ON-SITE SEWAGE DISPOSAL SYSTEM
HOWARD COUNTY HEALTH DEPARTMENT
BUREAU OF ENVIRONMENTAL HEALTH
3525-H ELLICOTT MILLS DRIVE, ELLICOTT CITY, MD 21043

SUBDIVISION: High Forest Estates LOT NUMBER: 34

ADDRESS: 15205 Open Land Court PROPERTY OWNER: Big Branch Overlook, LLC

<p align="center">BENCHMARK ENGINEERS • LAND SURVEYORS • PLANNERS</p> <p align="center">ENGINEERING, INC.</p> <p align="center">8480 BALTIMORE NATIONAL PIKE • SUITE 418 ELLCOTT CITY, MARYLAND 21043 PHONE: 410-465-6105 FAX: 410-465-6644</p>	PROJECT: HIGH FOREST ESTATES LOT 34	
	LOCATION: 15205 OPEN LAND COURT TAX MAP 27, GRID 6 - PARCEL 140,141,142 5th ELECTION DISTRICT HOWARD COUNTY, MARYLAND	
<p>BUILDER: TOLL BROTHERS, INC. 7164 COLUMBIA GATEWAY DRIVE SUITE 230 COLUMBIA, MARYLAND 21046 410-872-9105</p>	TITLE: PLOT PLAN	
	HOUSE TYPE: HAMPTON	
DATE: FEBRUARY 27, 2003	PROJECT NO. 1362	
SCALE: AS SHOWN	DRAWING 1 OF 1

PLAN

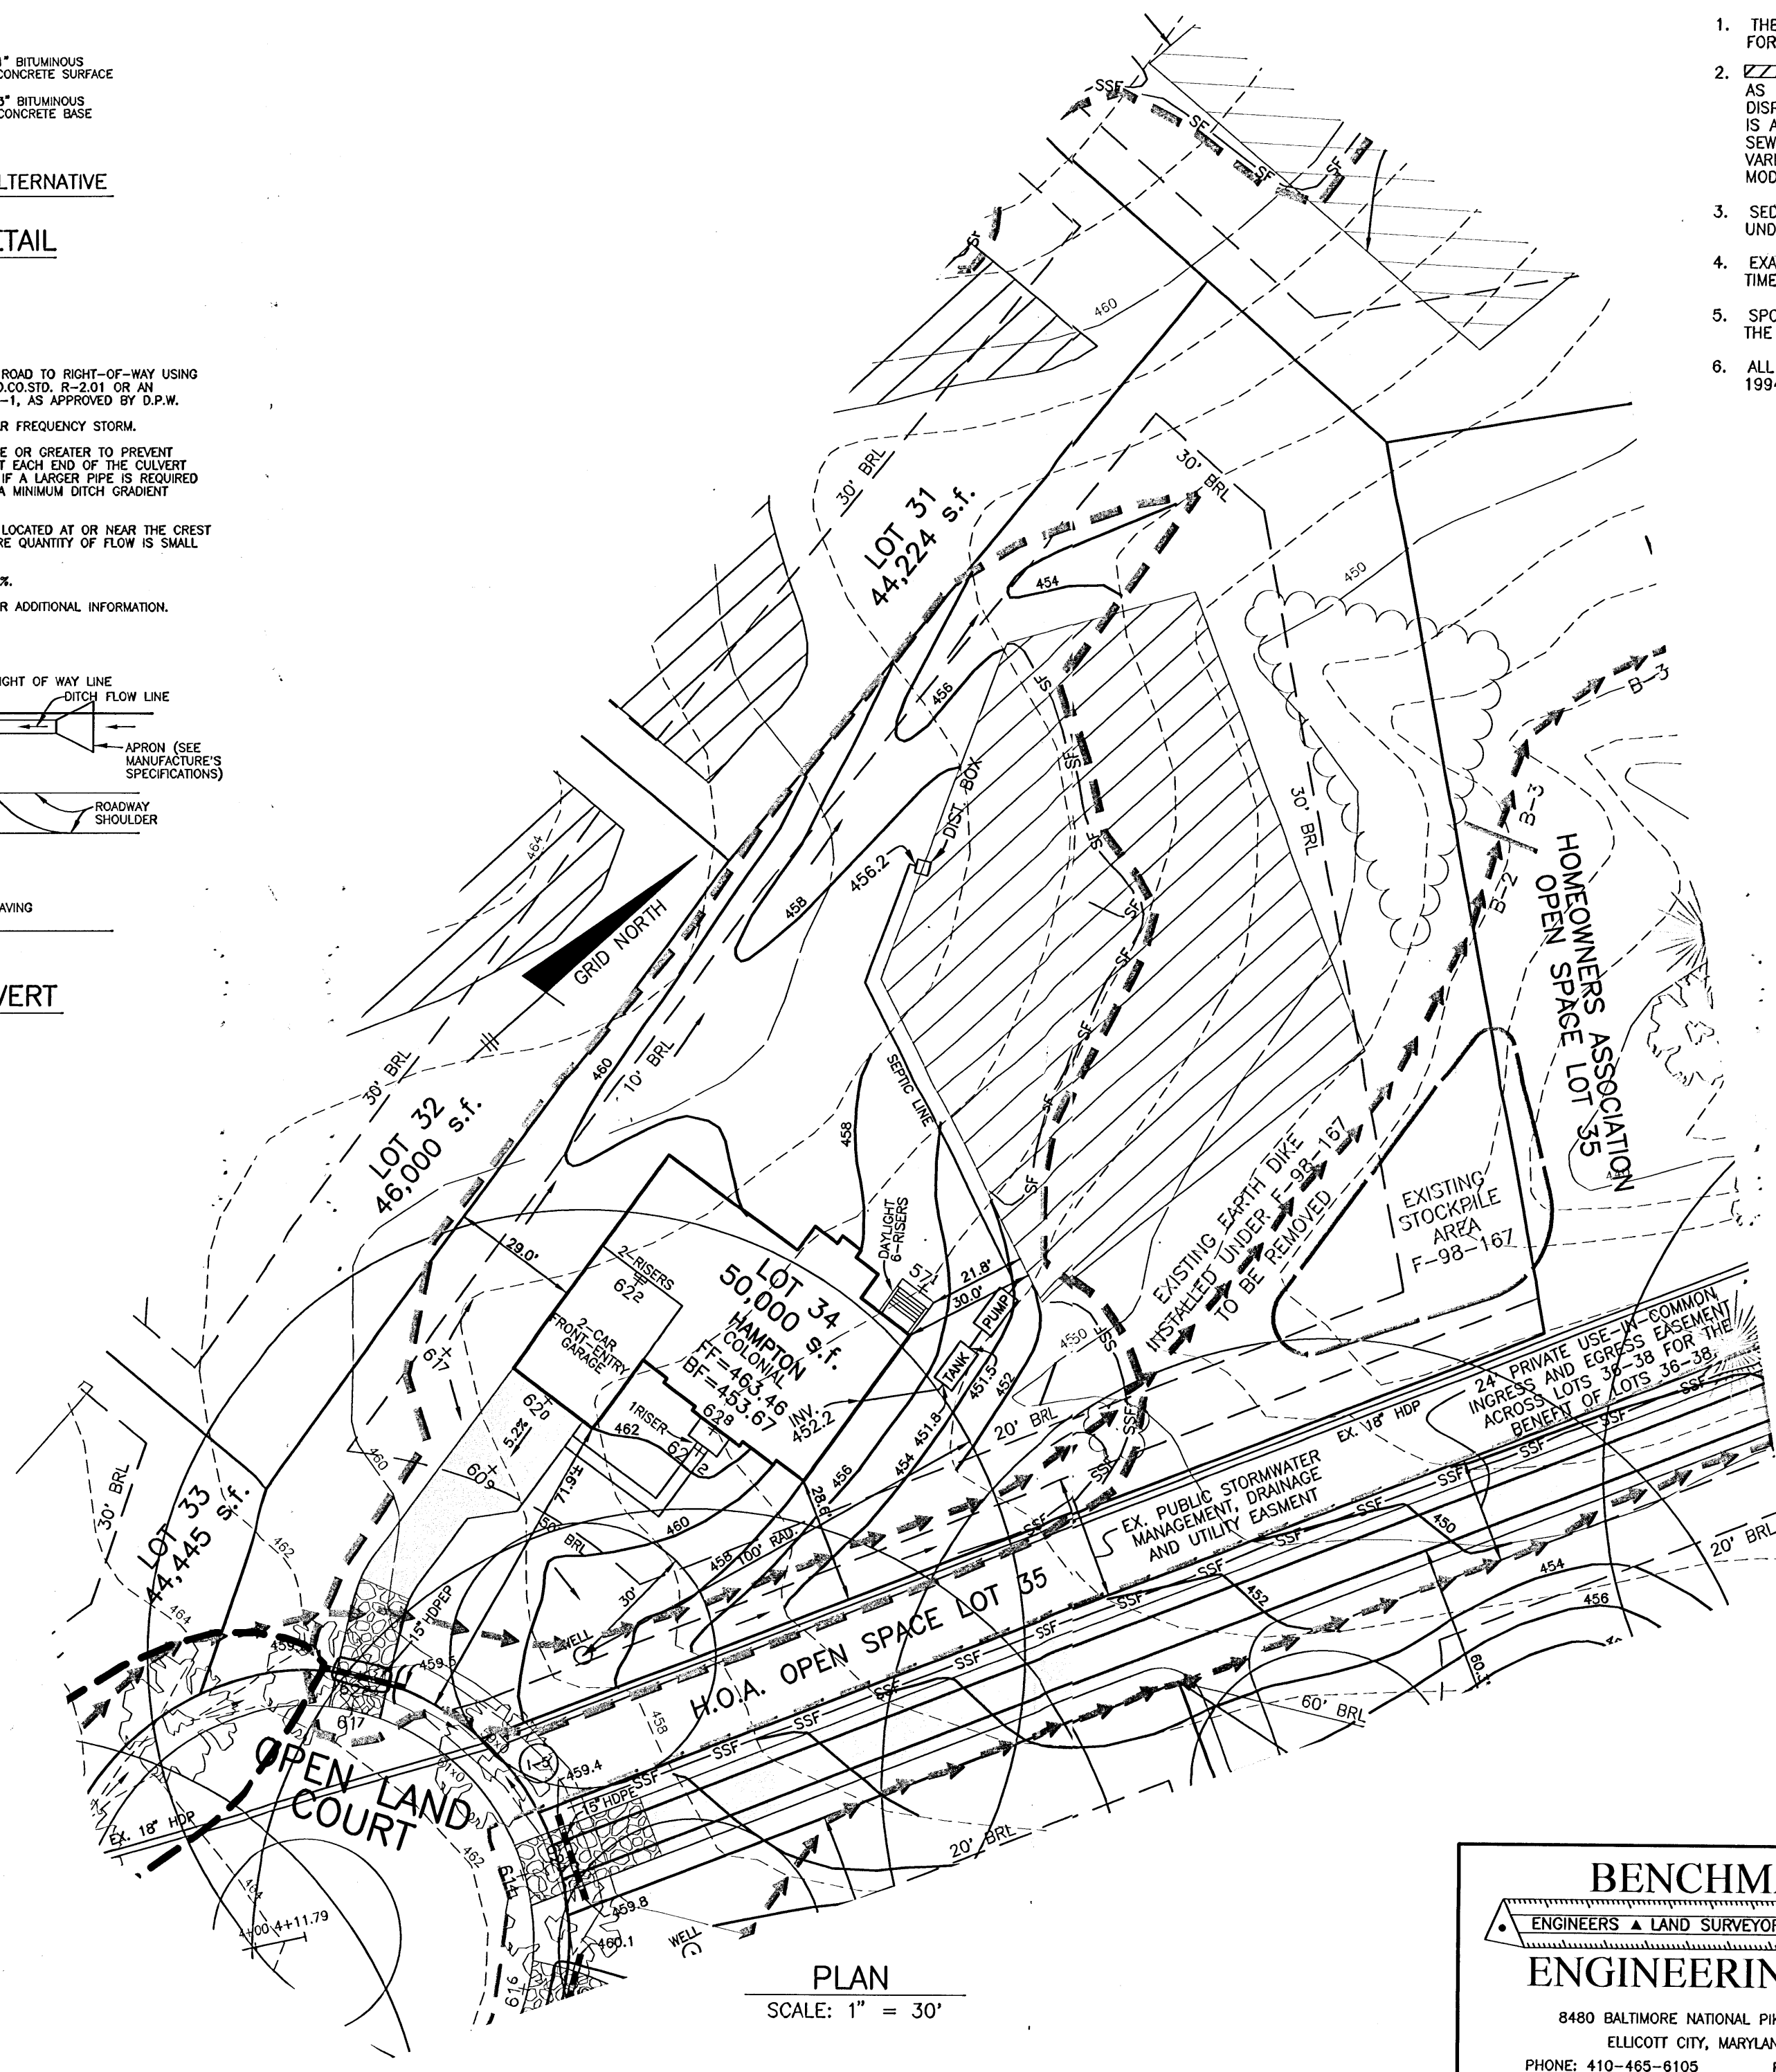
PRE-CONSTRUCTION 7/17/03 SRA staked, contour not accurate. Install 60'x30'x100' trenches w/ D.B. directly behind the house (SO)

INSTALLATION 7/18/03 Tanks set, trenches installed OK to cover work complete (SO) 7/21/03 OK to cover all work. Pump & Alarm tests needed (SO)

2-27-03 Septic Specs OK.
